HOLLEY ESTATES SUBDIVISION

APPLICATION NUMBER 15 DATE July 15, 2004	— Ņ
APPLICANT Holley Estates Subdivision	_ 4
REQUEST Subdivision	Ĭ
	MTS

DETAIL SITE PLAN

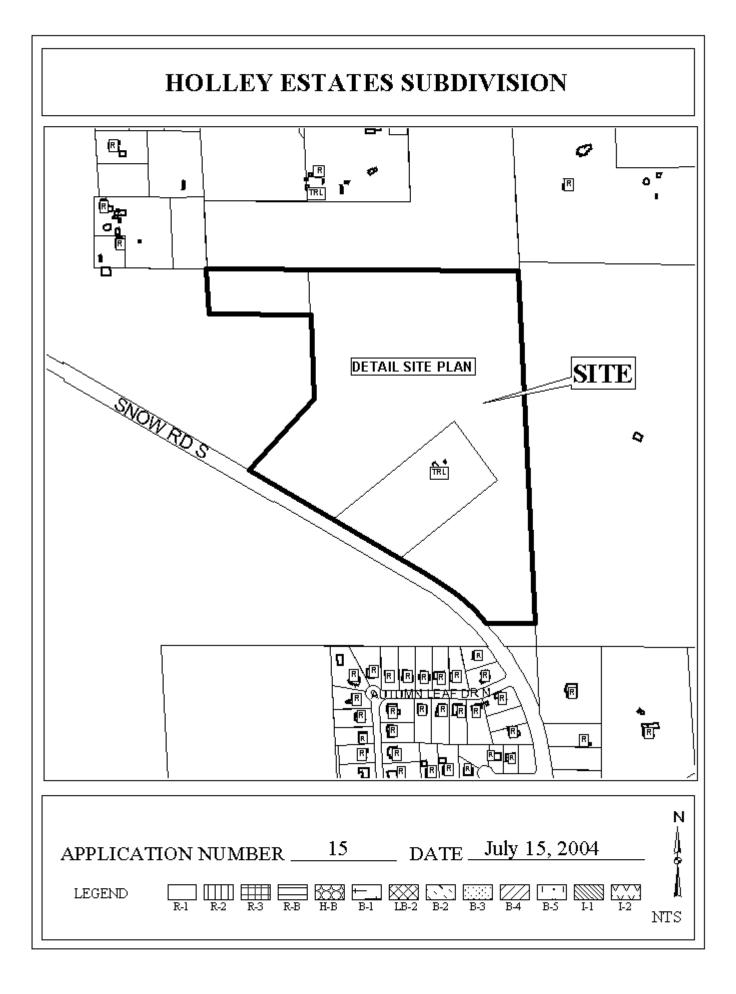
Snow Road South, which is a planned major street, has an existing right-of-way in compliance with the Major Street Plan. As proposed, Lots 1, 14-17, 29-32, 63-64, and 67 would front both Snow Road South and the new streets. In order to provide proper access management along the major street, the placement of a note on the final plat stating the Lots 1, 15-17, 29-32, 63-64, and 67 are denied direct access to Snow Road South should be required.

Section V.B.1 states that when a proposed subdivision is adjacent to large unsubdivided land, a street stub should be provided top allow for convenient circulation; therefore, the provision of a street stub to the East, should be required.

As illustrated on the Site Plan, the site contains wetlands, thus this area could be considered environmentally sensitive; therefore, the developer must obtain any necessary federal, state, and local environmental approvals.

The 25-foot minimum building setback lines are not shown but would be required on the final plat.

The plat meets the minimum requirements of the Subdivision Regulations and is recommended for Tentative Approval subject to the following conditions: 1) the placement of a note on the final plat stating the Lots 1, 14-17, 29-32, 63-64, and 67 are denied direct access to Snow Road South; 2) the provision of a street stub to the East; 3) the developer obtain any necessary federal, state, and local environmental approvals; 4) the placement of the 25-foot minimum building setback lines on the final plat; and 5) the placement of a note on the final plat stating any lots which are developed commercially and adjoin residentially developed property must provide a buffer, in compliance with Section V.A.7. of the Subdivision Regulations.
